**Request for Proposals Bill and Adele Jonas Center (Building 19),
Building 18 (New Childcare Facility) and Renovation of Building 17 (Old Library) for
Architectural and Design Services # 16/17-MB05**

**ADDENDUM #3
3/17/17**

Timeline for selection of Architect,
 Design Build Contractor and
 Construction Timeline
 Of Jonas Community Center – Indian
 Valley Campus
 College of Marin

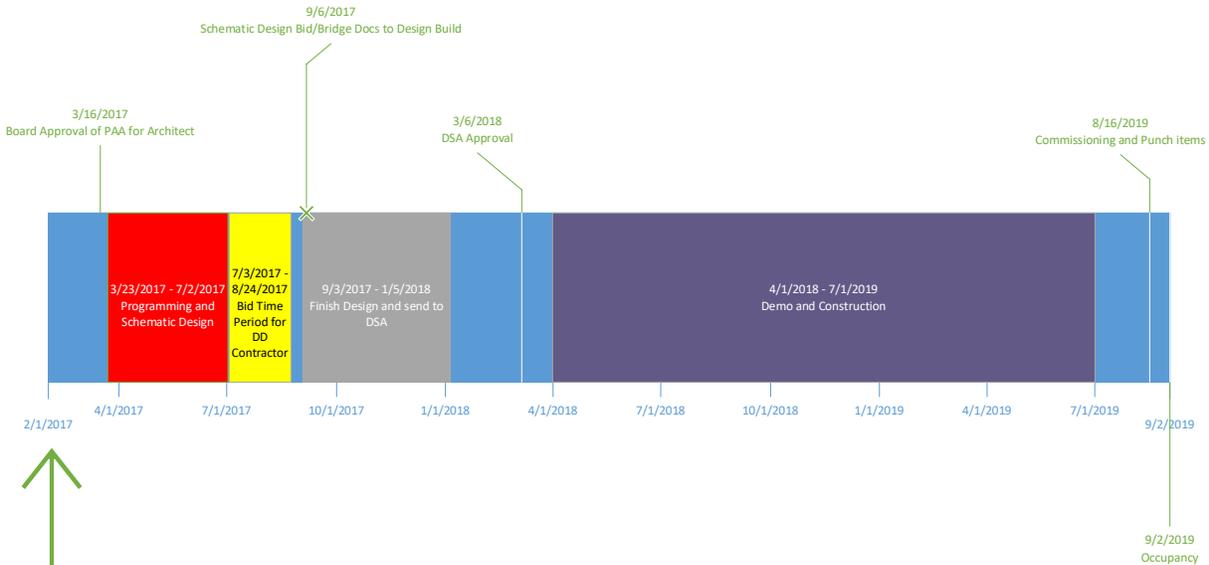
19. What is the anticipated project schedule for the Programming, Schematic Design, and Bridging Documents phases of the project?

Answer: see below chart. This is a rough schedule and not meant to be exact
